Development Application	5636/2021/MCU
Application Description	Material Change of Use – Community Use (Child Care Centre)
Location	54-56 Arthur Summervilles Road, KARALEE QLD 4306
Owner	Cherish Enterprises Pty Ltd
Applicant	Griffith Group One Pty Ltd
Reason for Referral	Contentious application receiving >50 submissions
Panel Members	Kate Isles – Planning (Chairperson) Shelley McCormack – Economics Dale Kleimeyer – Traffic

EXECUTIVE SUMMARY

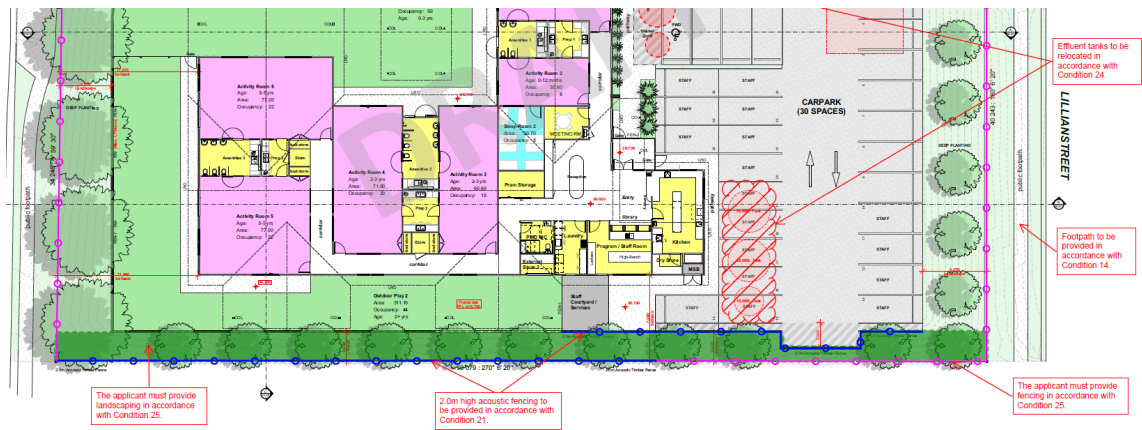
Based on a target occupancy rate of 70%, the need for child care places within the main service area is currently limited to 37 places, increasing to 71 places by 2026.

It is noted Specific Outcome SO3 (Non-Residential uses) of the Large Lot Residential Zone Code identifies *"each non-residential use fulfils a local community need; and is accessible to the population it serves..."*. In recognition of the assessment benchmarks, it is the panel's view that the development should be limited to a maximum of 75 places to ensure the non-residential use fulfils a local community need only and will be accessible to the (local) population it serves.

This would necessitate a change to proposed condition 6 (limits of approval) which currently sets a 100 children limit. In addition, the reduction in the maximum number of places may necessitate (or warrant) further design changes by the applicant and as such it may be prudent to seek for these changes prior to a decision on the application.

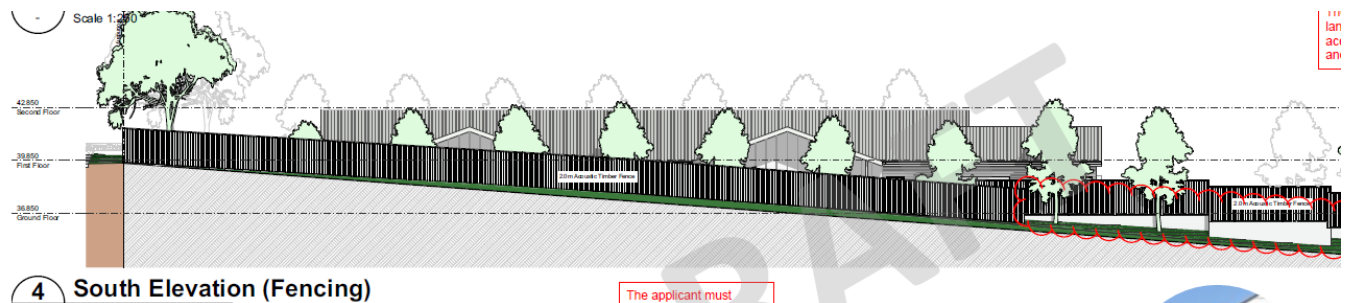
Probable Solution 2(d) of the Community Use Code requires a minimum ten (10) metre landscape buffer for the proposed development because the site abuts land in a residential zone. The applicant is proposing a 2.46m wide landscape buffer (average width) along the southern boundary of the subject site which will be partially behind acoustic fencing (that will be 2m in height along the boundary). Refer site plan below.

Whilst play areas supplement the landscape buffer on this boundary it is noted the building (roof) extends out over these play areas effectively to the edge of the landscape buffer and therefore being setback 2.46m from the southern boundary. The outlook of the adjoining southern property is represented in the section below, with the outermost projection of the roof pitch being setback 2.46m.

It is noted Specific Outcome SO3 (Non-Residential uses) of the Large Lot Residential Zone Code requires non-residential uses to maintain a scale and appearance in keeping with the residential amenity and character of the locality with adequate buffering or screening to nearby residential uses. It is considered that the setback of 2.46m to the building and the 2.46m landscape buffer **is not** in keeping with the large lot residential amenity and character of the locality and that inadequate buffering is provided to the nearby residential use. The Panel also notes, that the landscape buffer requirements for other non-residential land uses outlined in the Community Use Code 2 (c) are a minimum of 4m (with this development proposing 2.46m).

It is the panel's view that the landscape buffer and accordingly the building setbacks should both be increased to a minimum of 5m with the landscaping increased to provide additional large shade trees within the buffer that screen the building at mature height. These changes would necessitate amendments to the proposal plans.

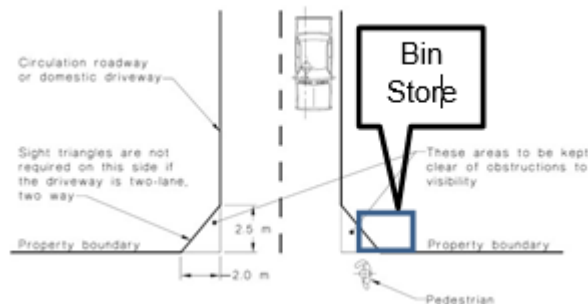
The development proposes to utilise holding tanks for effluent disposal which will be collected from the site via a truck. The tanks are to be located near to the northern boundary under the car park. The applicant proposes to install a holding tank venting system and sealed hatchets are to be utilized to ensure odours are vented via the release point. Council officers have conditioned a sewage management plan (draft condition 24) which requires additional details on the sewage arrangements.

It is understood the tanker pump out is to occur outside child care centre operating hours and may commence as early as 4am. The panel considers pump outs occurring this early as inappropriate for the locality and conditions should be included to ensure pump outs occur during trading hours or at other times which will not adversely affect amenity. In doing so consideration will be required to ensure that the service vehicle can undertake the works in the event there are cars parked in the designated car spaces.

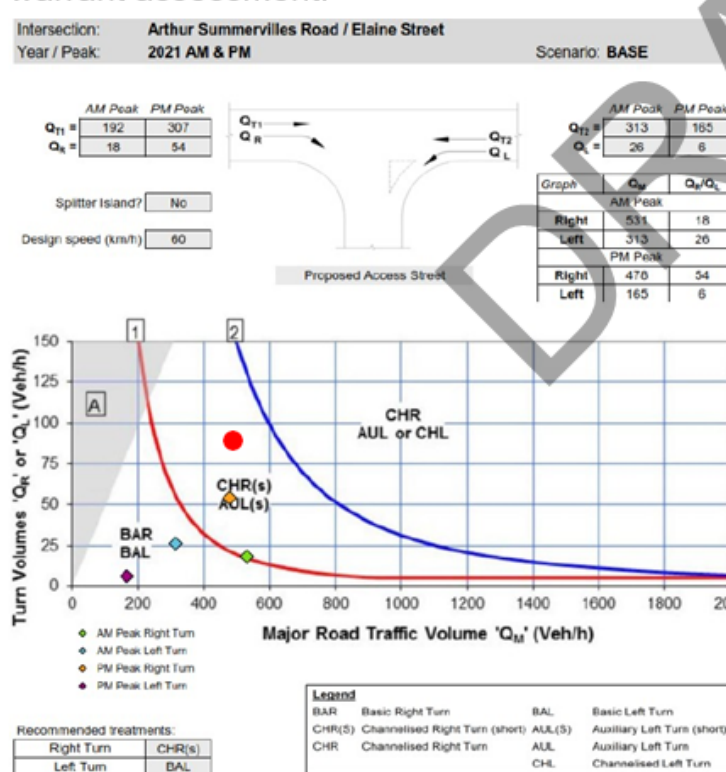
The Panel has undertaken a review of the internal carpark layout and raises a number of concerns with the layout as presented in the proposal plans. Specifically:-

- The driveway is offset from the car parking aisle and too narrow for simultaneous cars entering and leaving. The lane width available is not sufficient space for two B99 vehicles to pass. Car space 27 (red highlight) is therefore in a vulnerable position with no median kerb protection from the aisle. This is an unsafe outcome which should be reviewed and rectified.

- The bin store area partially obstructs pedestrian sight line on exit which is non-compliant with AS2890.1. This outcome should be reviewed and rectified.

- No turning bay has been provided which results in visitors entering to reverse out along the entire length of the aisle which is unsafe. This outcome should be reviewed and rectified.
- The current proposal plans and draft conditions (condition 11) require 17 staff car parking spaces to be provided. Whilst the applicant has provided spaces as per the nominated staff per each identified room, it is unclear if provision has been made for the actual number of staff servicing the entire development, which also include office and support staff such as the centre manager (typically based on-site), cook/chef and float staff (i.e. those staff who cover shifts during lunch breaks to ensure staffing

requirements in each room continue to be met). Based on earlier comments regarding the limitation of the size of the centre to 75 the number of car spaces should be reviewed and amended accordingly as part of revised plans.

- (e) There is no parking zone identified in the car park for a service vehicle and there is insufficient space with a service vehicle internal to the site to enter and leave in a forward gear.

The panel recommends that the internal car parking layout issues identified (a) – (e) above are reviewed and appropriately conditioned as part of the Officer's recommendation.
